ADDENDUM

Project: **Crestwood School District
Crestwood High School
Field Building & Site Improvements**

Date: **March 29, 2023**

Addendum Number: **#3**

C4.1

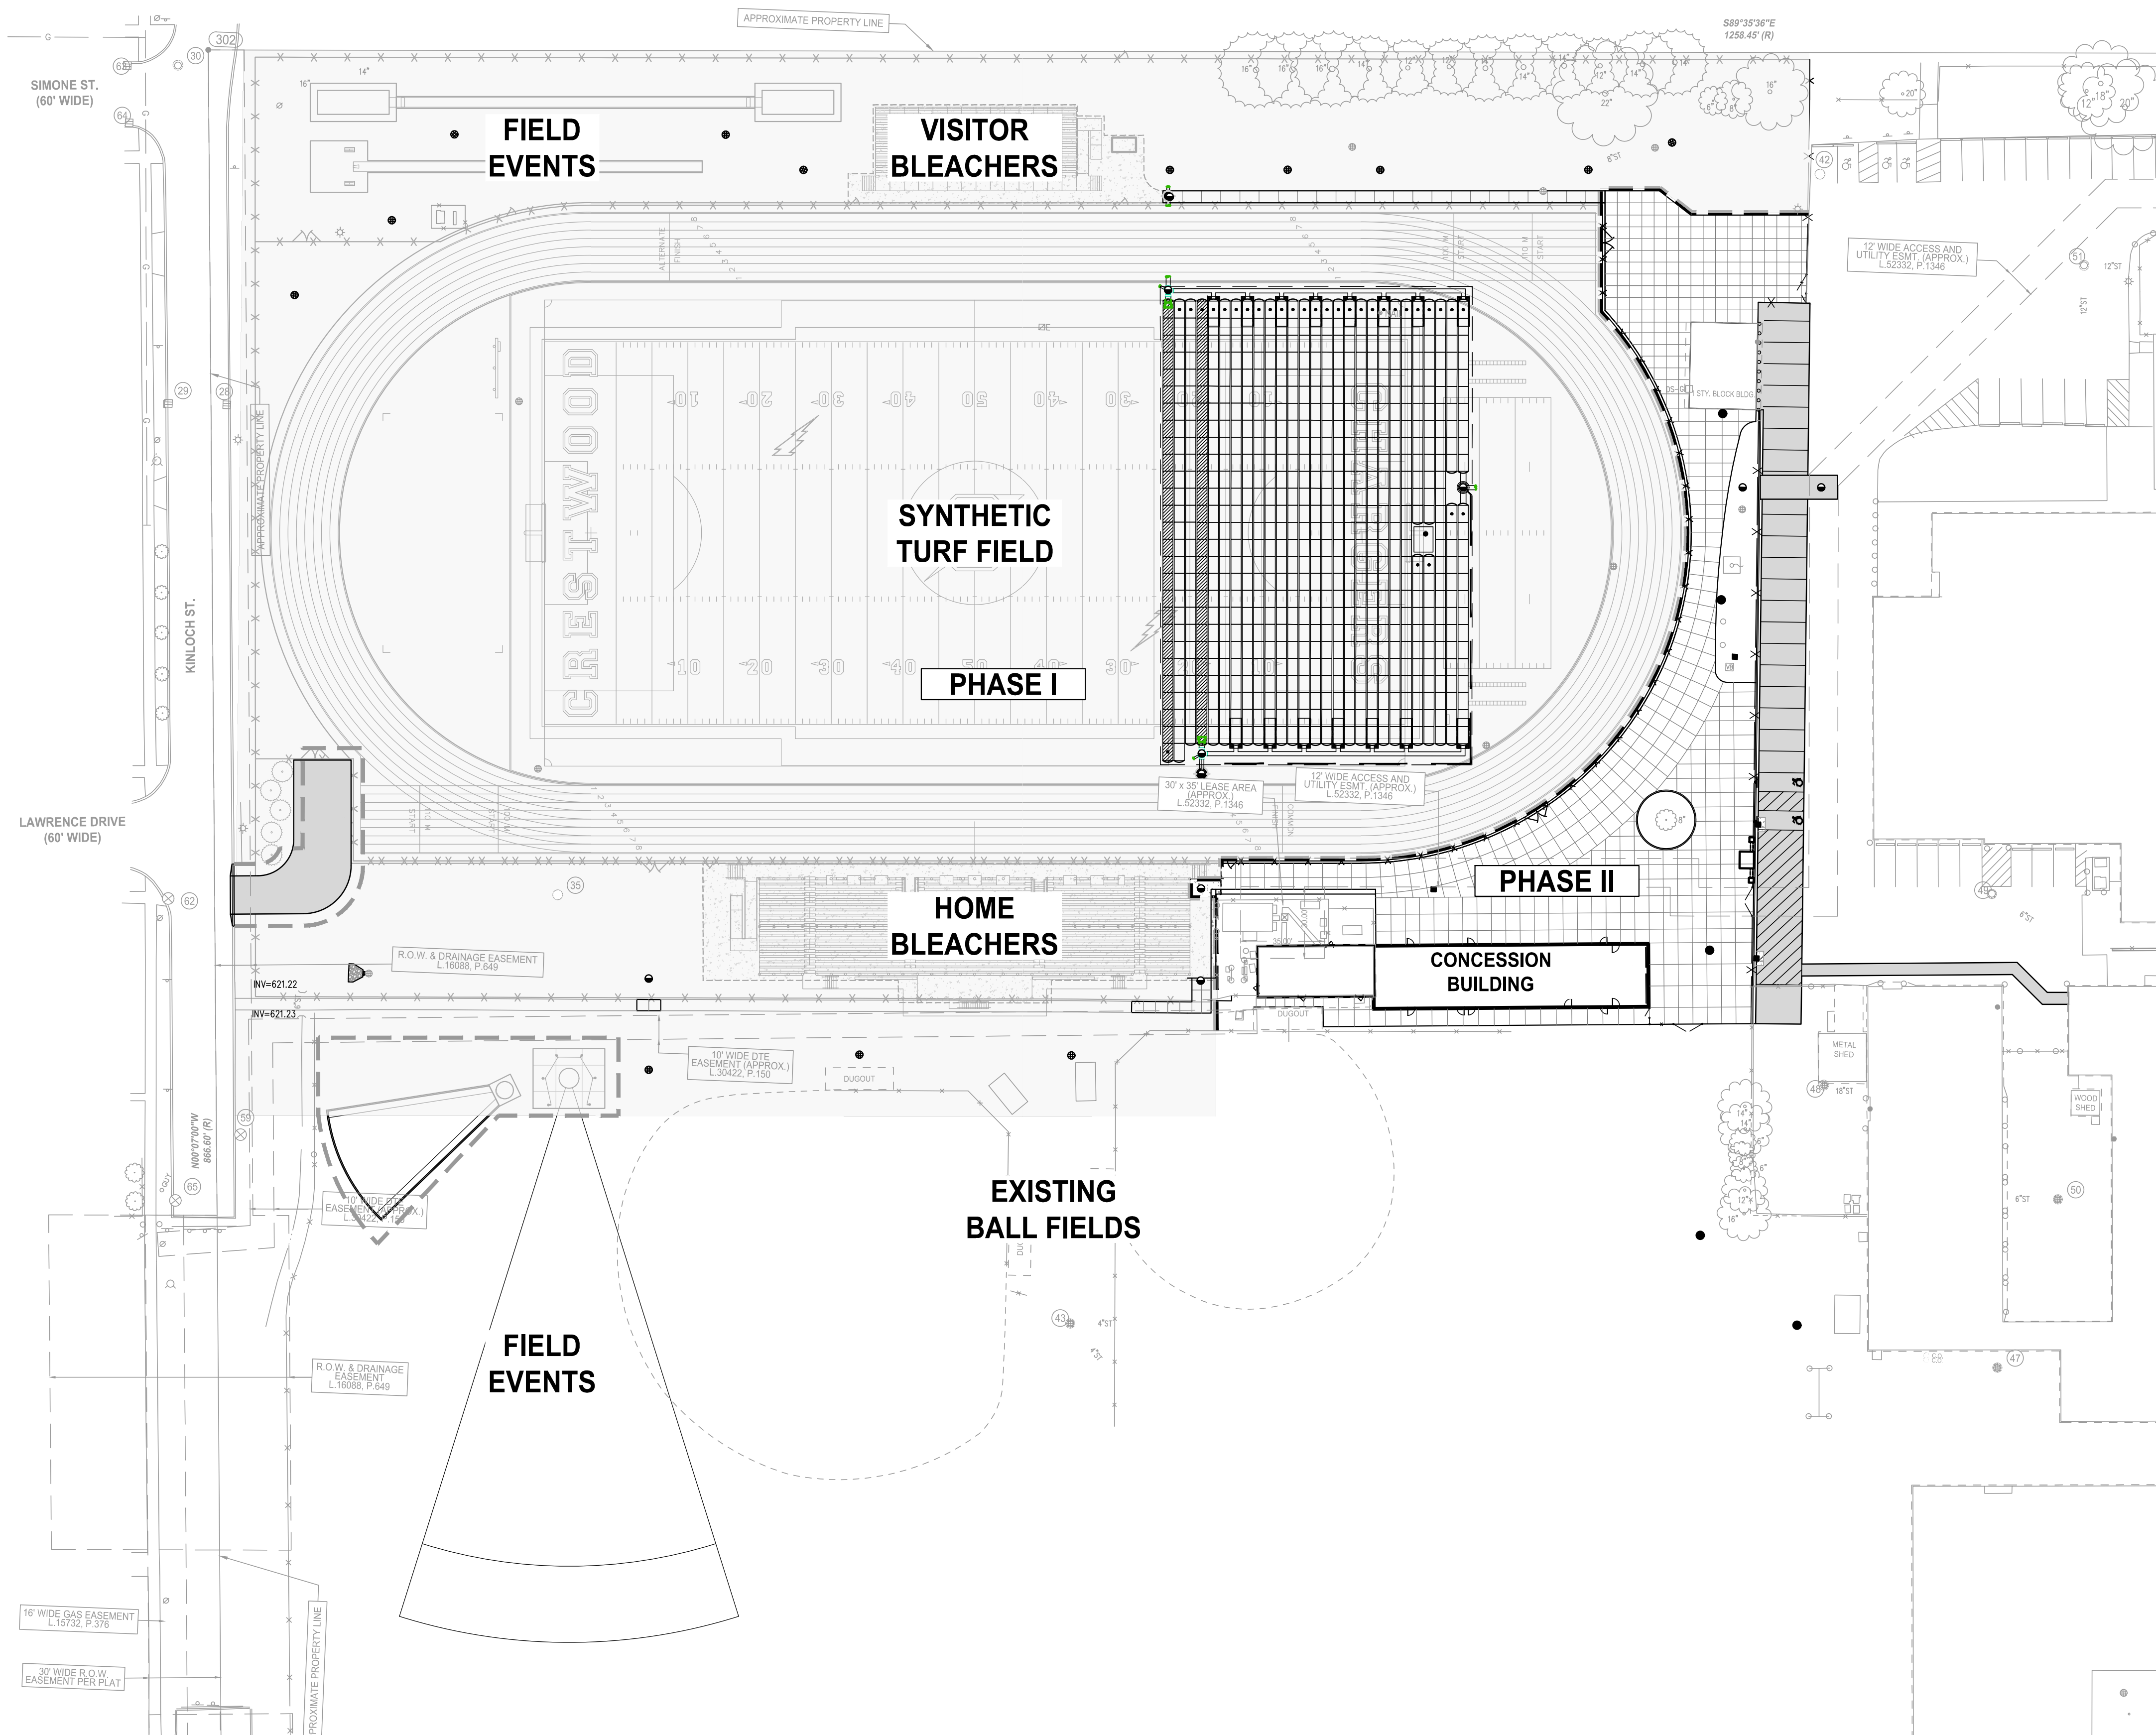
- Adjusted the watermain trench limits.
- Added “BOLLARD” detail as well as bollard detail callout in plan.

A0.12

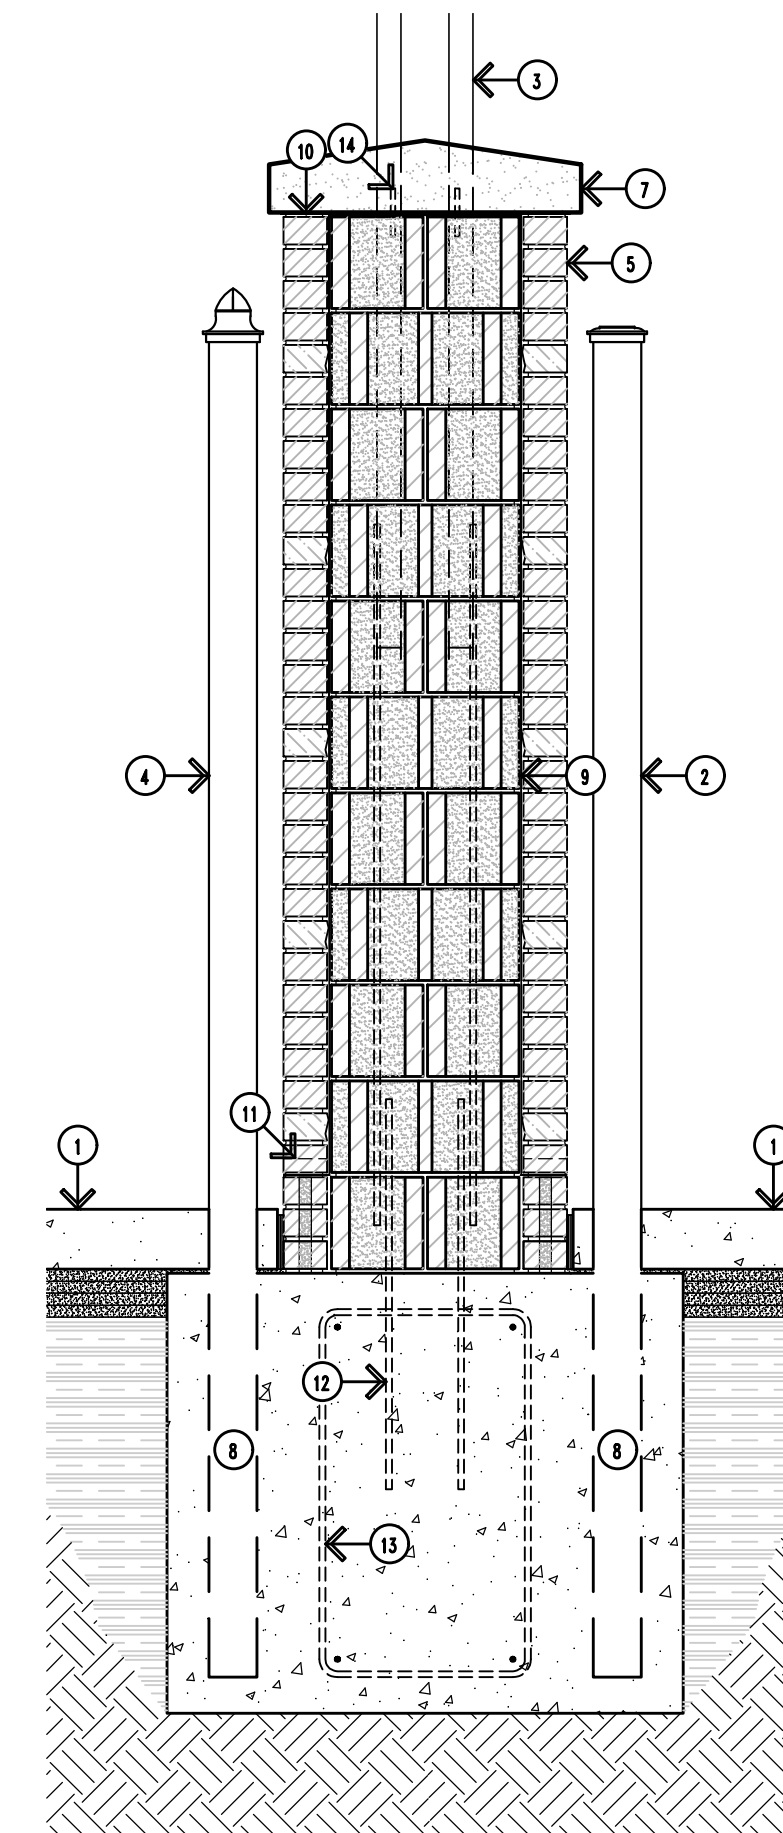
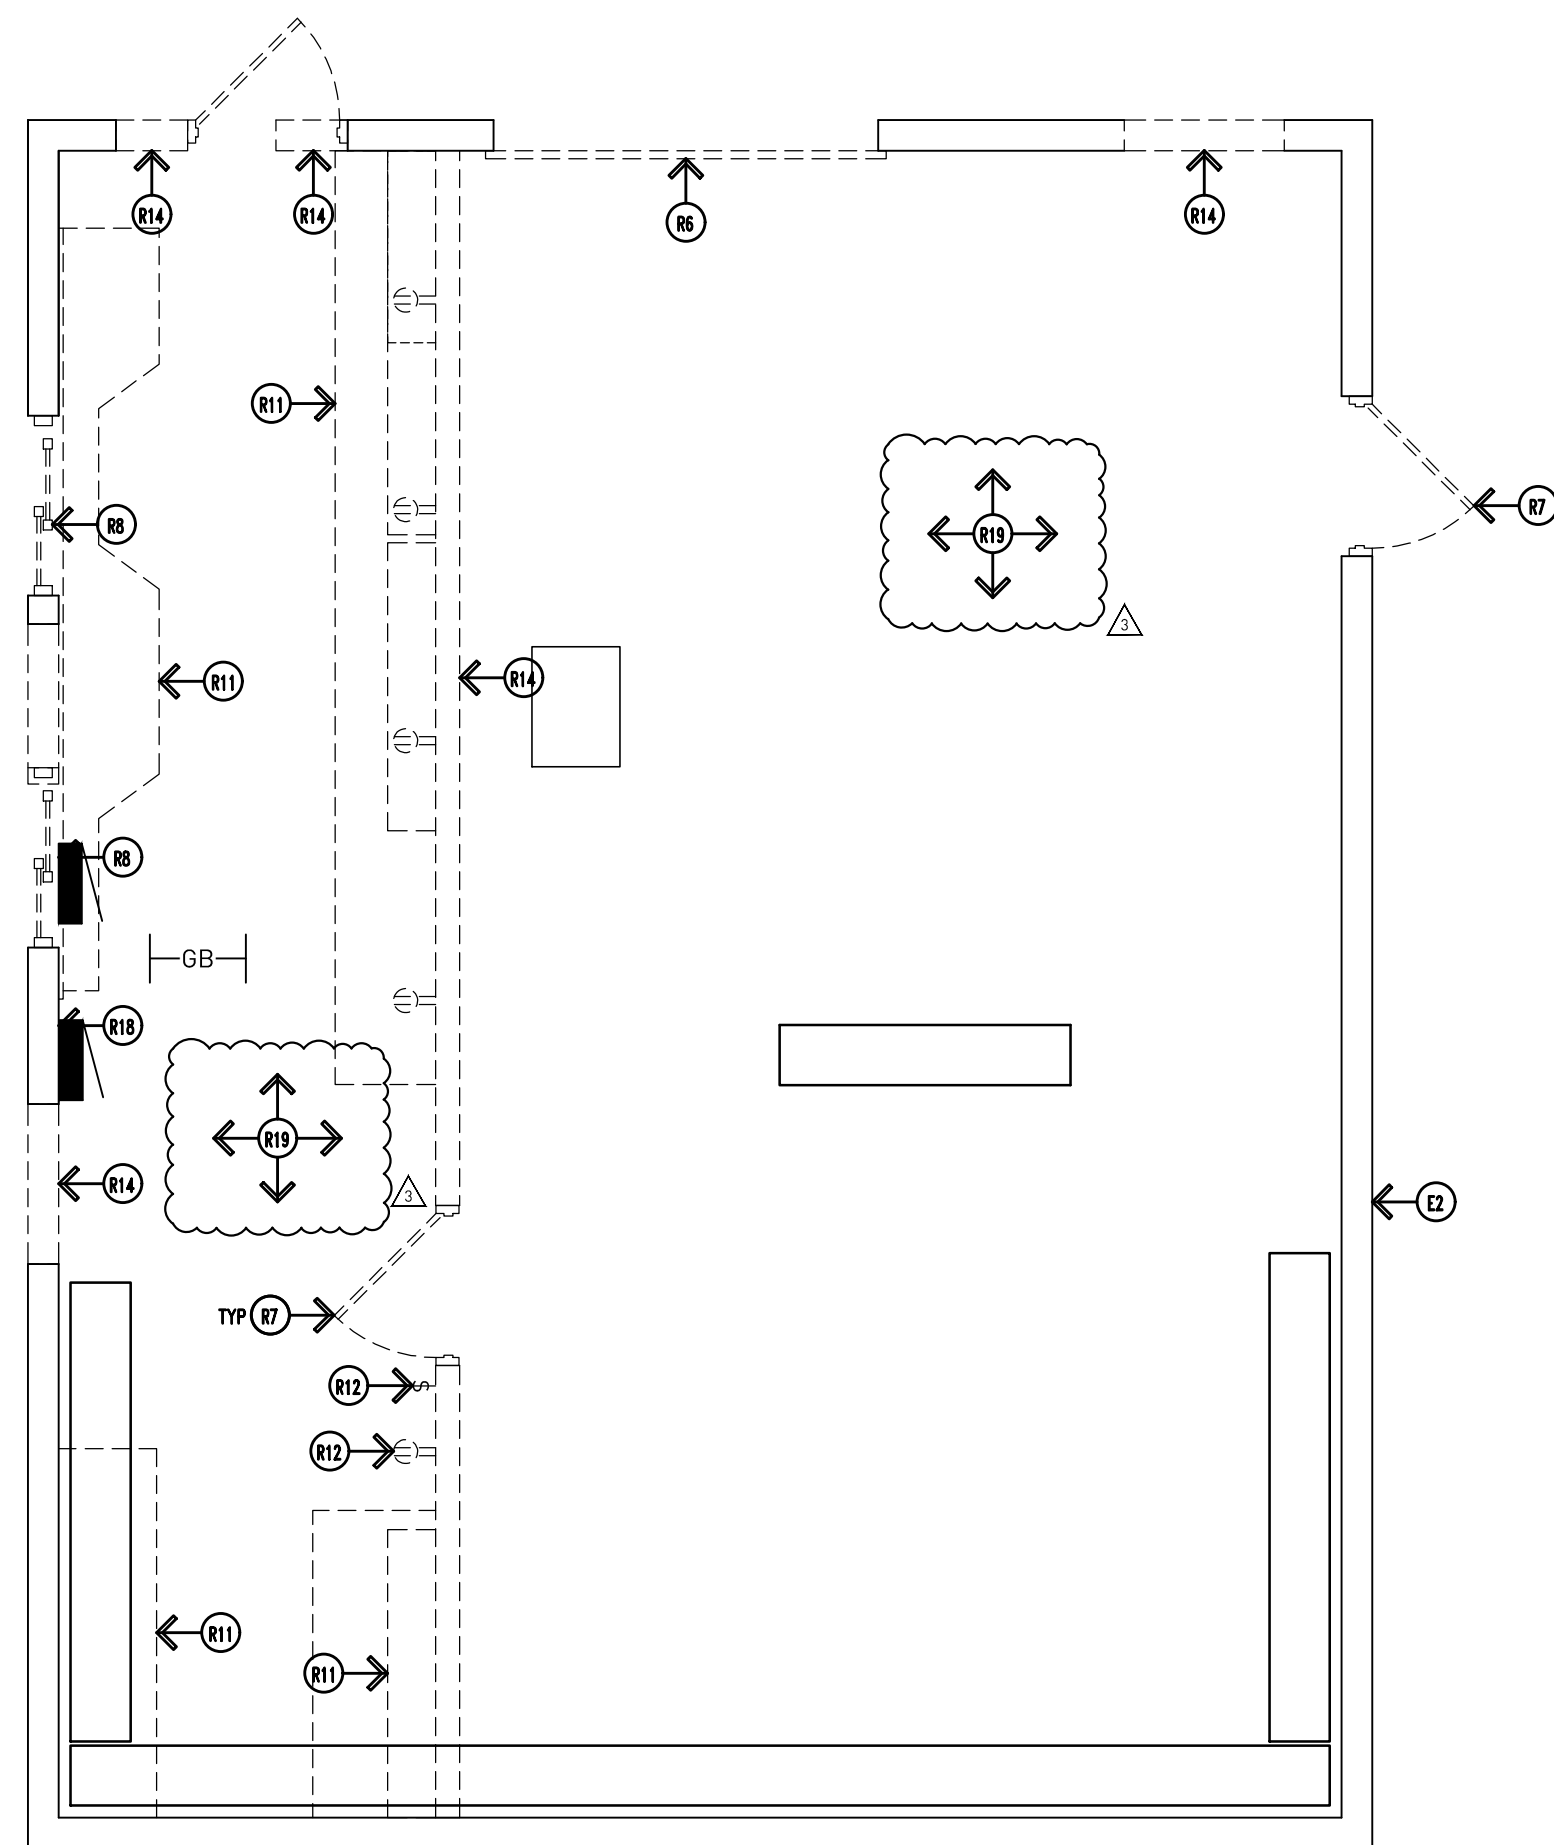
ADD: Sheet A0.12 Architectural Site Plan & Details

RFI Answer 22: Refer to the re-issued architectural sheet A0.11 and the added sheet A0.12 for further information.
